STATE OF NORTH CAROLINA  
DEPARTMENT OF TRANSPORTATION

Subject: **Neuse River Buffer Authorization Modification Request** for US 70 (Clayton Bypass) from I-40 to US 70 Business in Wake and Johnston Counties, State Project No. 8.T311002, TIP No. R-2552, NCDOT Divisions 4 and 5, WBS Element 34459.1.1.

Reference: Neuse River Buffer Authorization dated January 14, 2005 (WQC Project No. 041760)

PROJECT REFERENCE NO.		SHEET NO.	
R-2552AB		10	
R/W SHEET NO.			
ROADWAY DESIGN ENGINEER		HYDRAULICS ENGINEER	
CONST. REV.			
R/W REV.

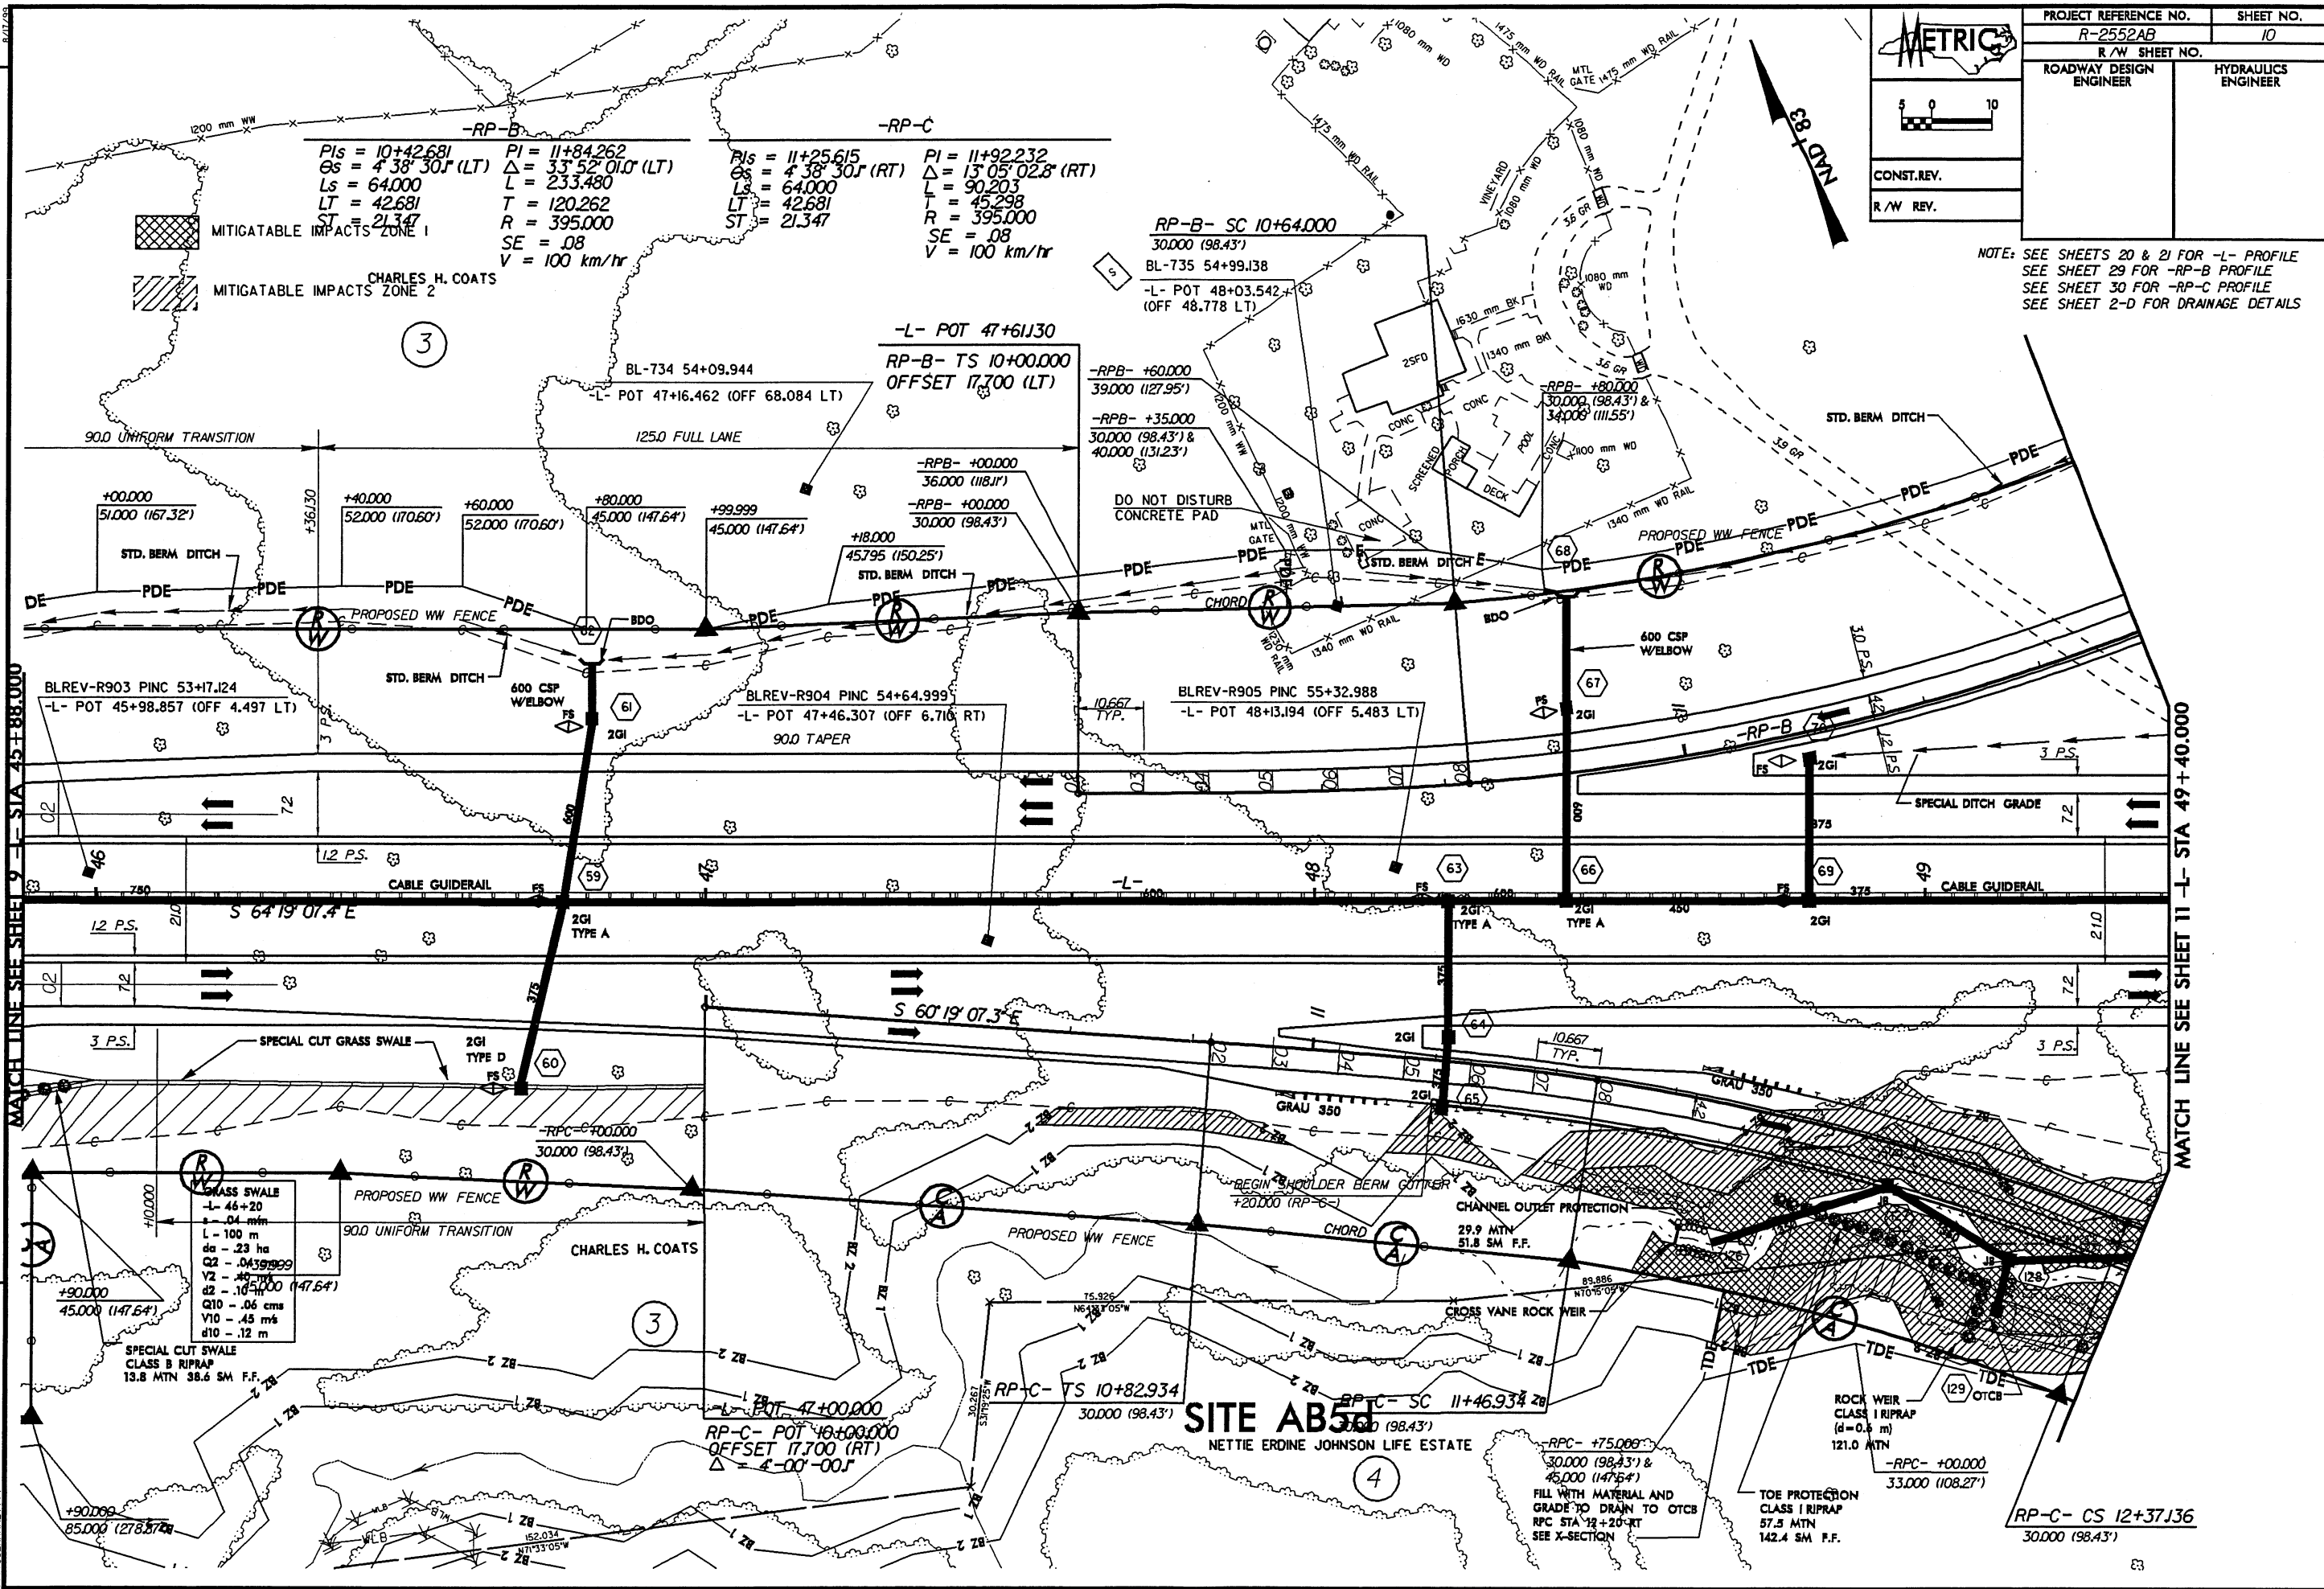
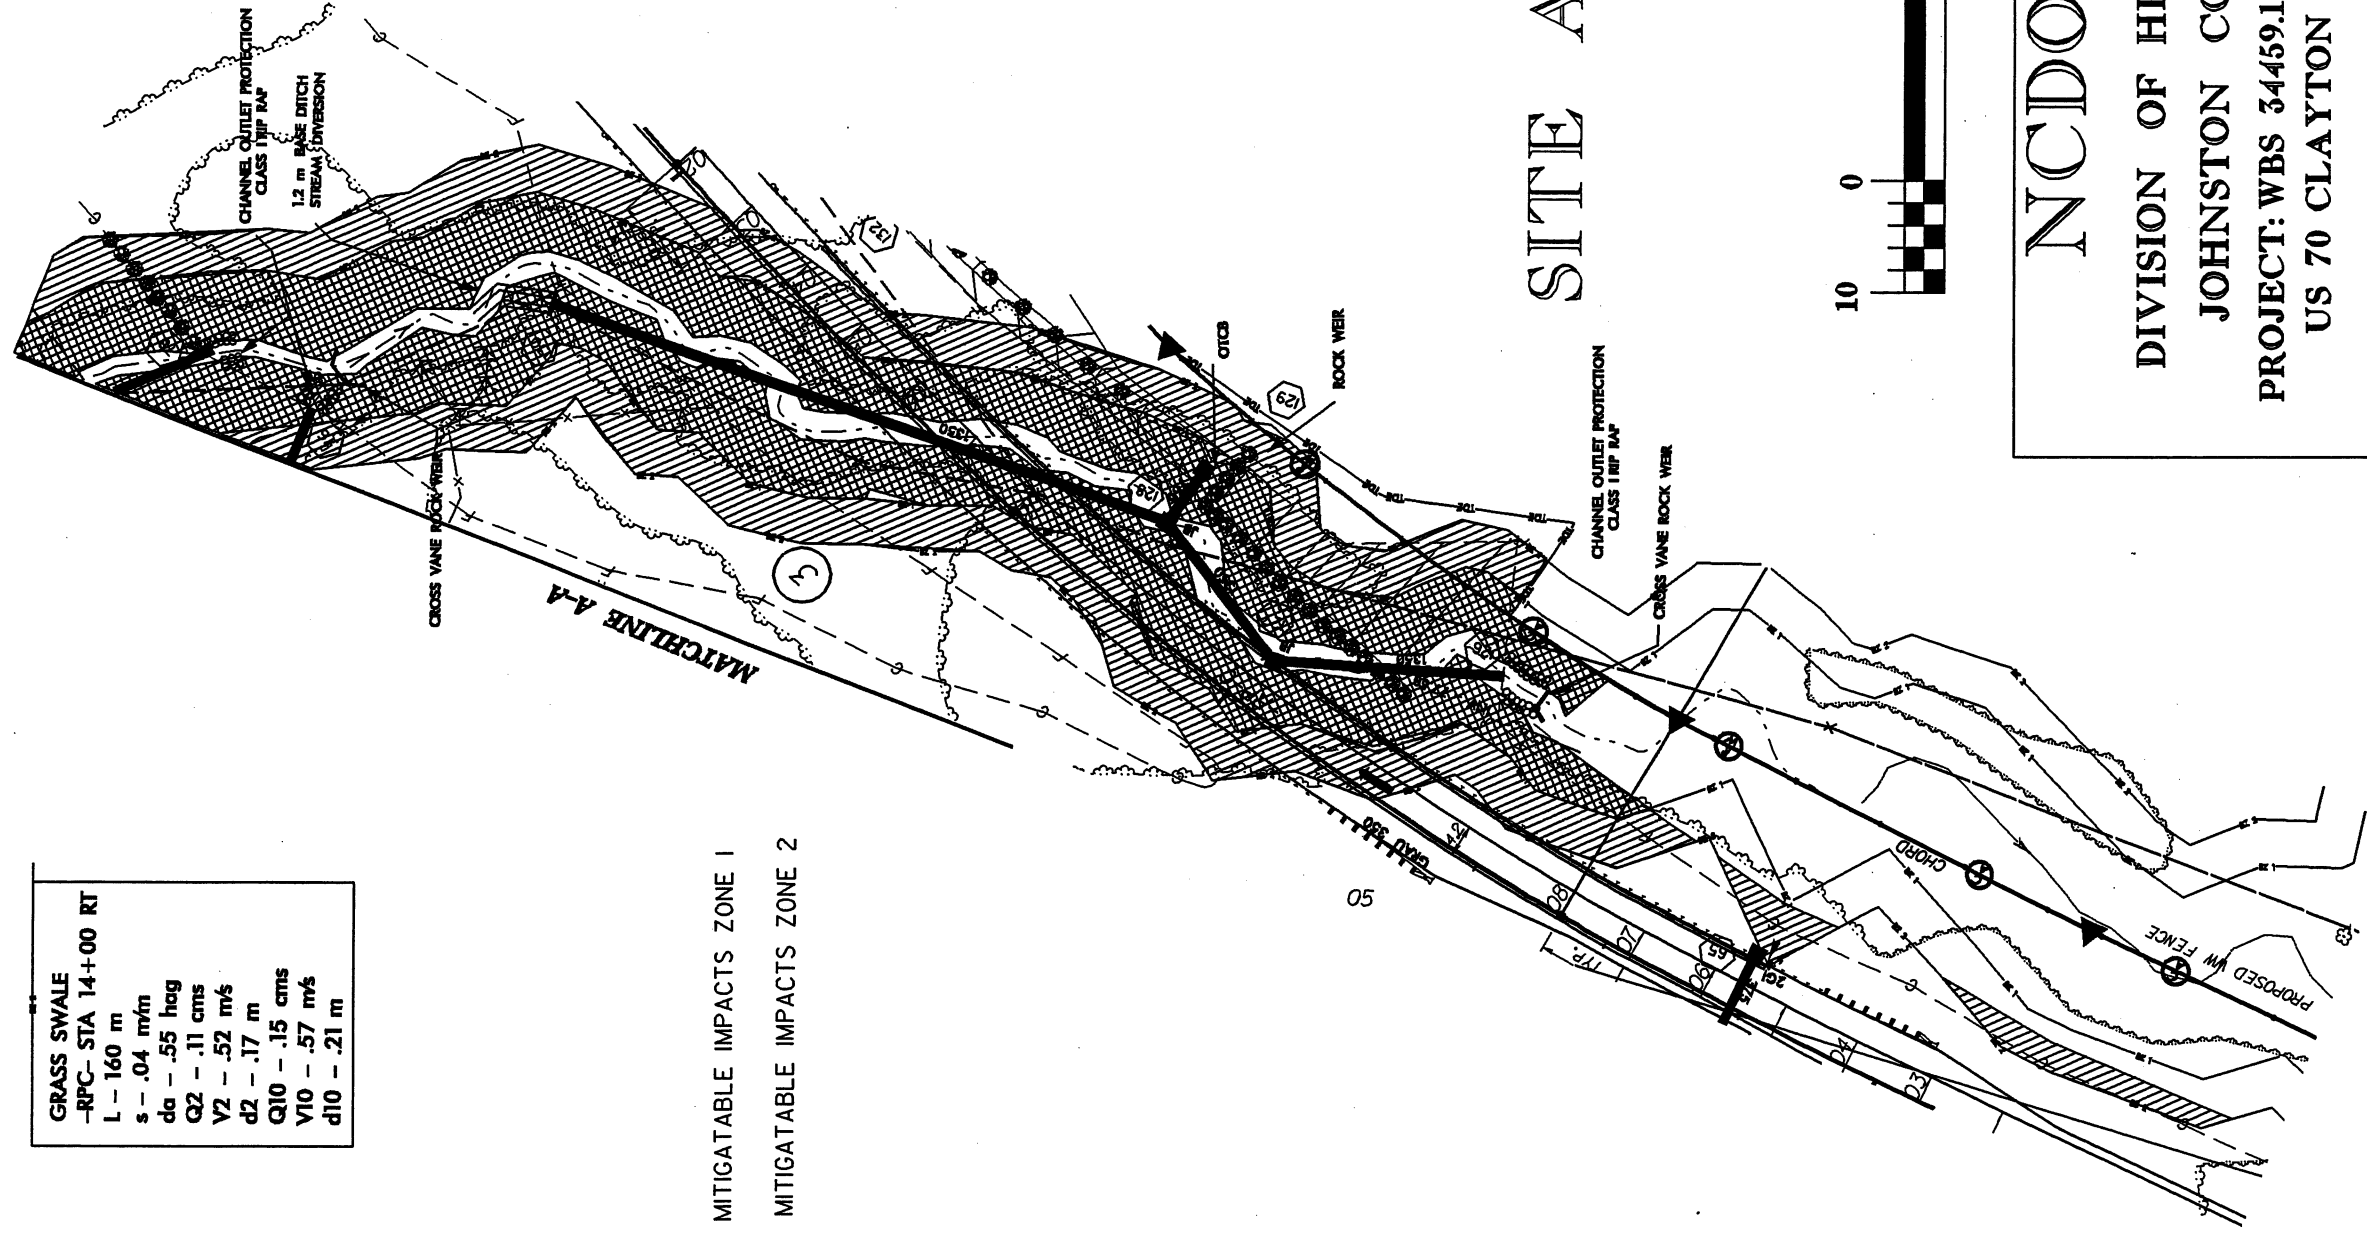
It appears that a site was inadvertently omitted from the Neuse River Buffer permit drawings on the R-2552AB project along Ramp C at the NC 42 interchange. The specific site is a continuation of Site AB5d.

There are two issues in particular at this site (see attached map). There are additional impacts to Buffer Zone (BZ) 1 and 2 that can easily be seen within the slope stake line when reviewing Roadway Plan Sheet # 10. Those impacts are a continuation off the end of Site AB5d. However, in reviewing the general area along Ramp C, the blue-line stream has apparently meandered closer to the proposed Ramp C in some locations thereby requiring additional impacts to BZ2. The attached drawing indicates the field located BZ1 and 2, and highlights the existing and proposed impacts at this location. These revisions account for a reduction of 129.50 square ft of riparian buffer impacts in Zone 1 and an increase of 1463.82 square ft of riparian buffer impacts in Zone 2. No additional mitigation is proposed since the impacts at each site are not equal to or exceed 0.3 ac or 150 linear ft.

NCDOT requests that the referenced Neuse River Buffer Authorization is modified to reflect the revisions outlined in this letter. We are providing seven copies of this application to the North Carolina Department of Environment and Natural Resources, Division of Water Quality, for review.
